RESPONSES TO CURE DATA REQUESTS MOTION TO COMPEL

(DRs 37, 38, 51, 52, 56, 57, 58, 59, 64, AND 67)

Carrizo Energy Solar Farm

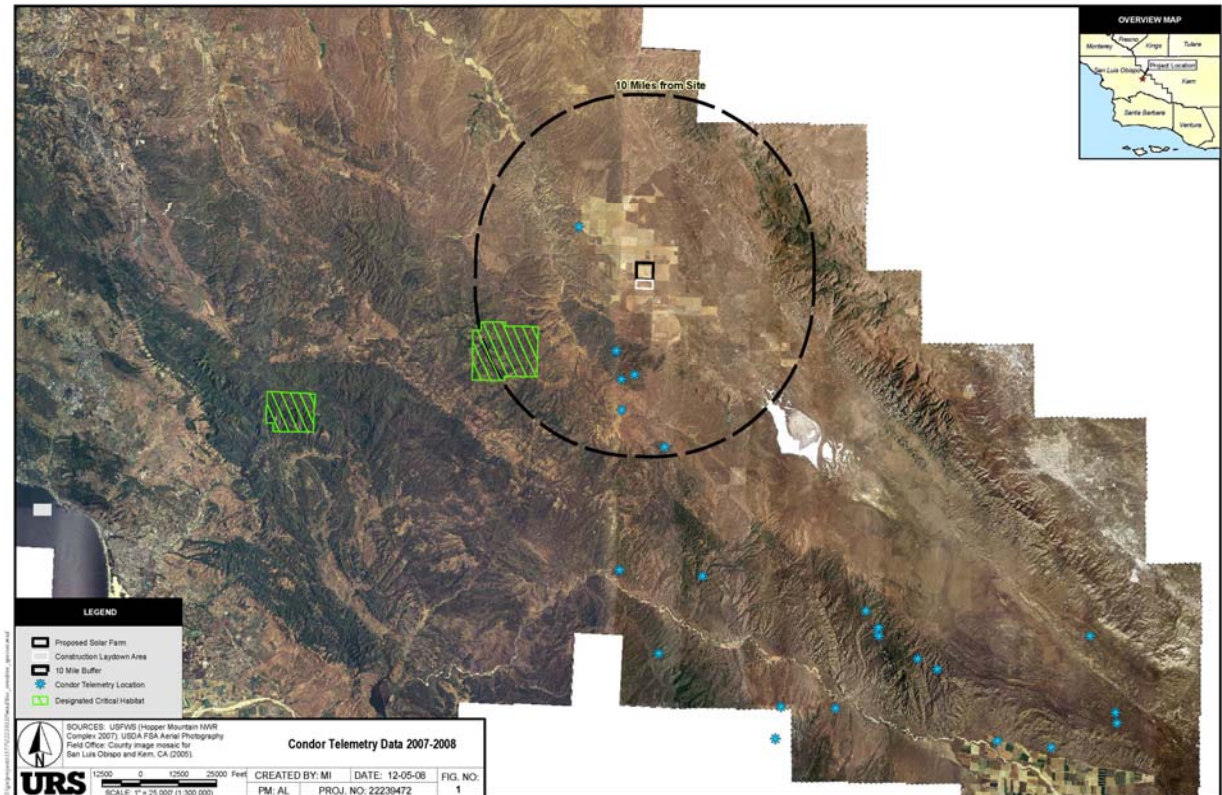
Data Request 51: Since endangered California condor live in the Carrizo Plain and the USFWS Recovery Plan states that the Carrizo Plain provides foraging for the condor, please provide an analysis of the Project's impacts on the foraging habitat and restoration of the California condor population.

Committee Response: The Applicant's analysis to date indicates that the endangered California condor is not currently active in the vicinity of the project. However, CURE argues that the condor can travel as much as 150 miles foraging for food, which could potentially place condors at the project site. Staff also notes in its PSA (p. 4.2-11) "the possibility that condors may be encouraged to return to the area." Applicant argues that the cattle operator at the site now removes dead cattle, thereby limiting attractions for foraging condors. However, local residents have commented that leaving dead cattle on other adjacent properties is a more common practice. The Motion on this request is Granted.

Radio telemetry data from the USFWS Hopper Mountain National Wildlife Refuge (2007-2008) indicates that the condor do not use the Project area. While it is true that condor can travel up to 150 miles to forage, the radio telemetry study shows the condors flying in a north-south direction along the ridgelines and foothills of the Caliente Mountain Range west of the Project site. Additionally, GPS records from 1910 to 1987 show that the condor were historically associated with the foothills and more topographically diverse areas around the valley. The nearest condor was recorded in 1983 more than 5 sections away from the CESF Project site (USFWS 2008). There are no records of the condors flying east over California Valley or the Carrizo Plain. Please see the Figure provided below. Based on this information, no impacts to condor foraging habitat are anticipated as a result of the Project.

Potential reintroduction of California condor to the area is speculative and cannot be used in the assessment of the Project. The impact assessment cannot be based on speculative actions that are not documented in any existing, approved planning document that has been subject to public review and comment. California Valley is dominated by privately owned lands and such a wildlife agency management action would need to be assessed under CEQA prior to implementation. The Applicant is unaware of any such analysis to date. Therefore, reintroduction of condors into this area is speculative, which makes it very difficult to assess the potential impact of this Project on this species. At this time, the data shows the species do not use this area and are therefore not impacted.
